Remote
REMRVCRC.SCH

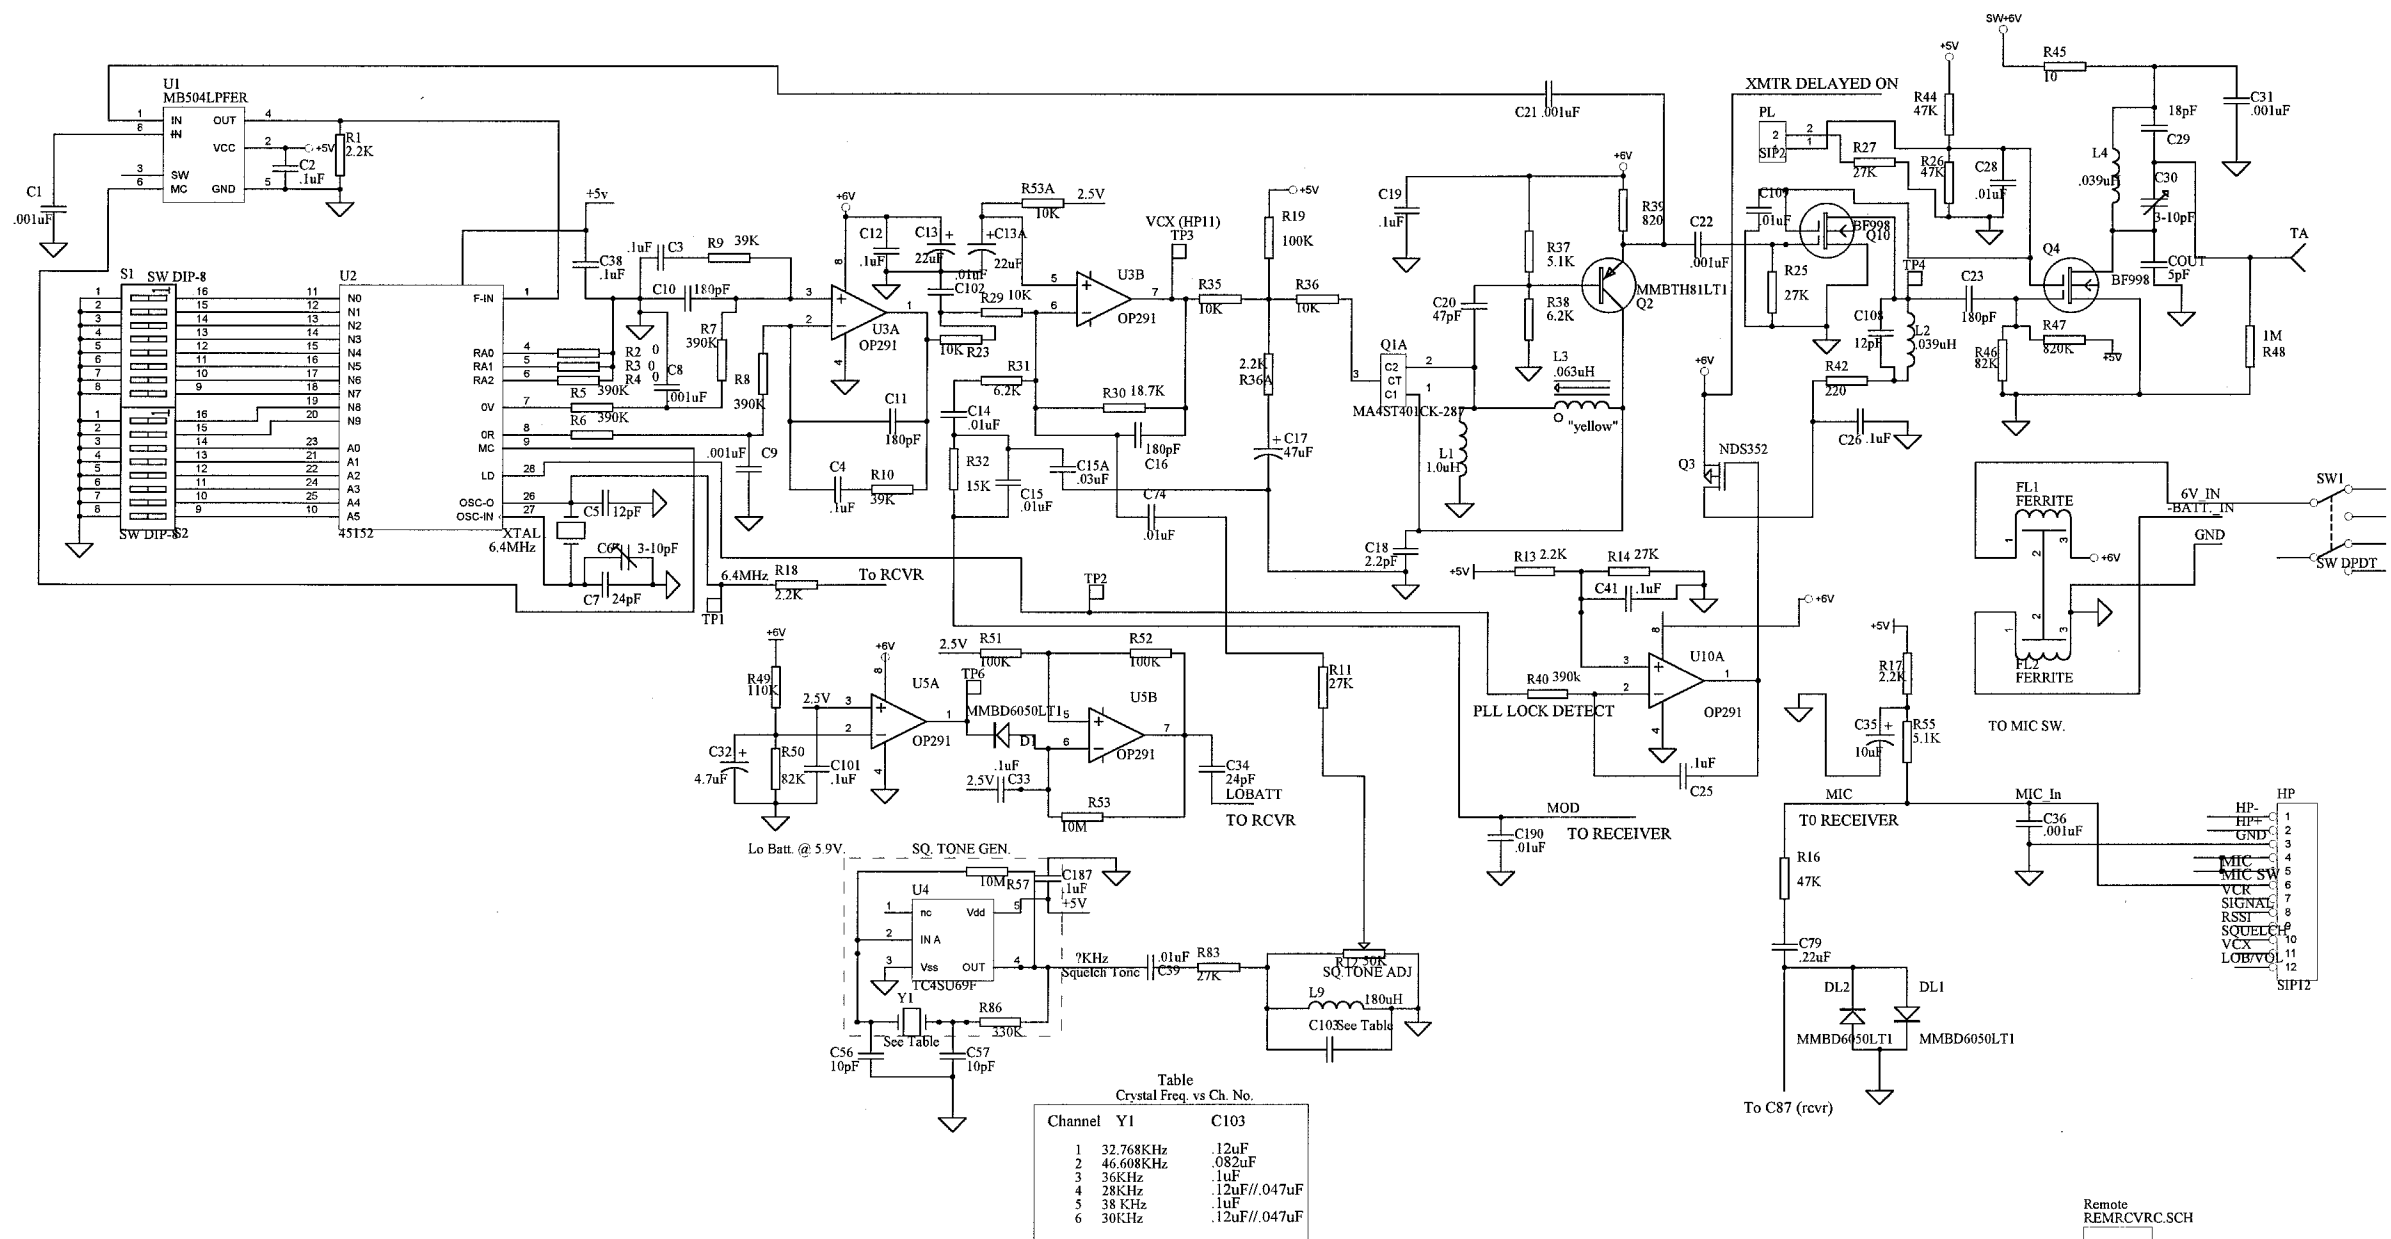
Change: C27 to C20, R57 to 10M, R42 to 220, R45 to 10, C29 to 12p, C36 to .001, R27 to 27K, C34 to 24pF, R26 to 47K, HP to 12 pin, R49 to 110K-1%
Add: COUT = 5pF, C79 = .22uF, R16 = 47K, C15A = .022uF, DL1 & DL2 = MMBD6050LT1
